Addendum

Addendum No: 01
Date Issued: 11.04.2011

Project:	City of San Antonio Emergency Operation Center Site Renovations	Issued to:	City of San Antonio
HOK Project No:	09.09010.00	Attention:	Cathleen Crabb Kenneth Heinzmann

SUNDT 911
BOLLARD

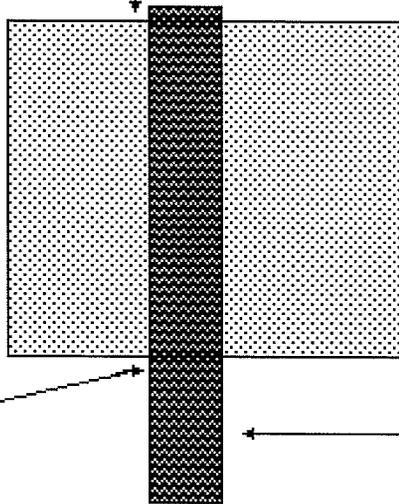
3. See attached revised City of San Antonio Unit Pricing Form.
4. See attached fence cable catch bollard Details. These details are not replacing any drawings, but are in addition to.

8"X8"X.25 THICK BLACK POWDER
COATED BOLLARD

2" OD SOLID STEEL PIPE
THRU 8" (.25) THICK BOLLARD
FILL BOLLARD WITH
CONCRETE AFTER 2" PIPE
WELDED IN PLACE

WERING POINT (PSAP) SITE

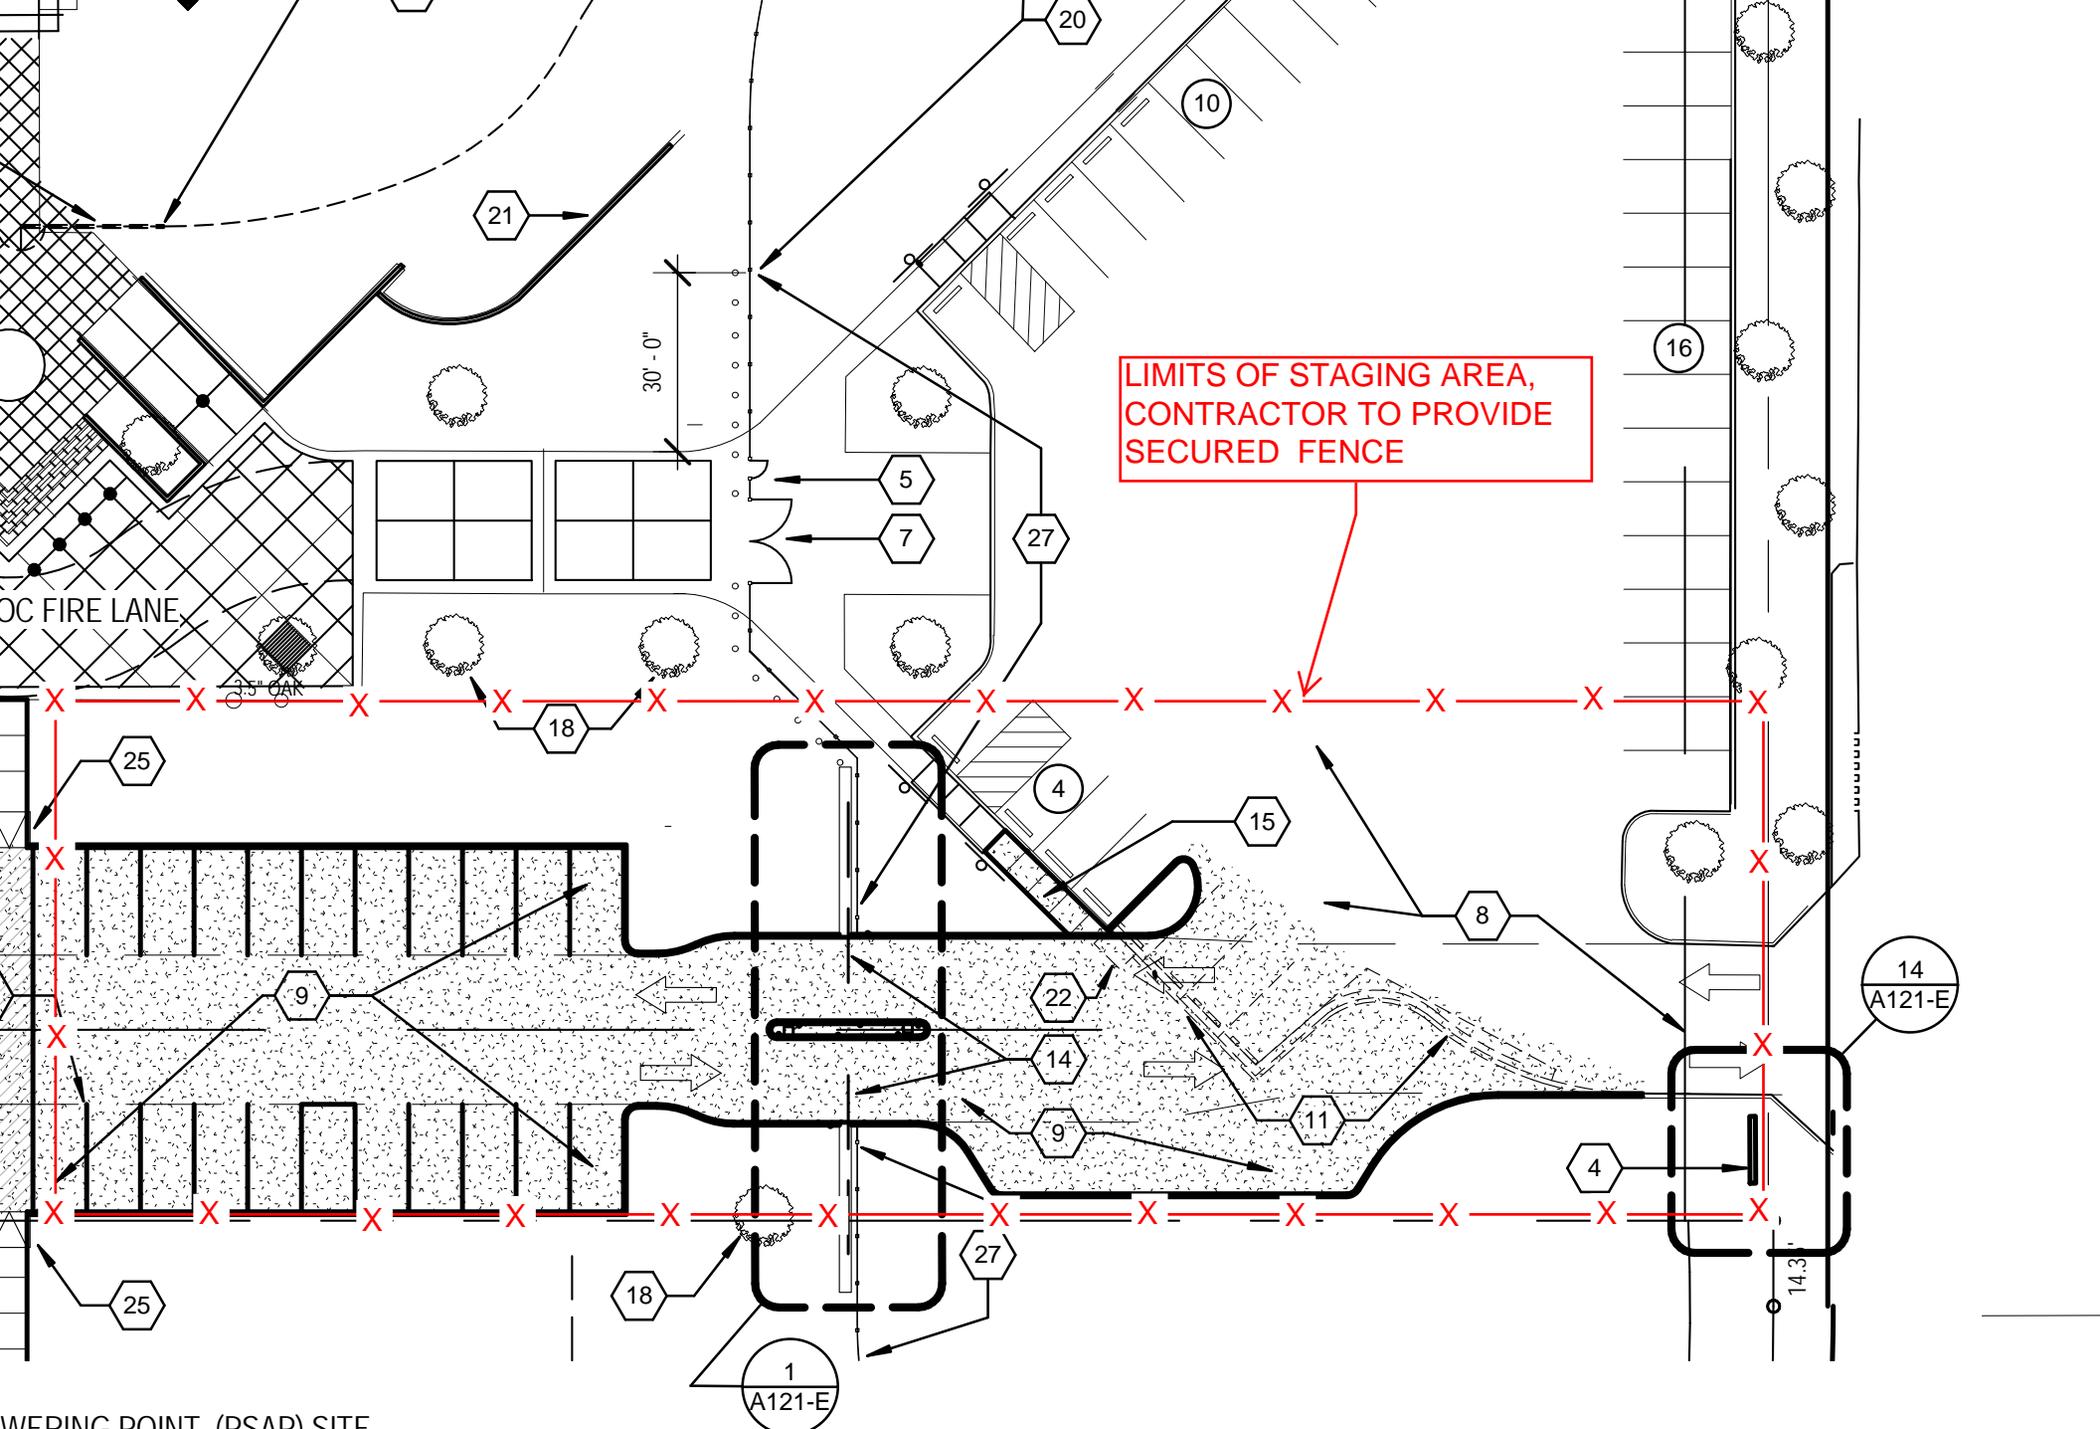
5. At the South of the PSAP (911 Call Center) property there is a 32' wide opening in the fence (4-8' panels) that will need to be closed after the completion of the EOC project. Currently this area is being used for PSAP vehicular access and will remain so until the end of this EOC project. The fence design and spec is to match the existing fence on the PSAP - 911 Call Center property and is also to match the EOC fence that has a continuous 18" concrete curb (Note 1 on sheet A101-E). Concrete footing and curb are to be included along with removal existing asphalt and providing a new concrete containment curb. Low emission vehicular signs will also be provided by owner and are to be installed to match adjacent. (See attached sketch)
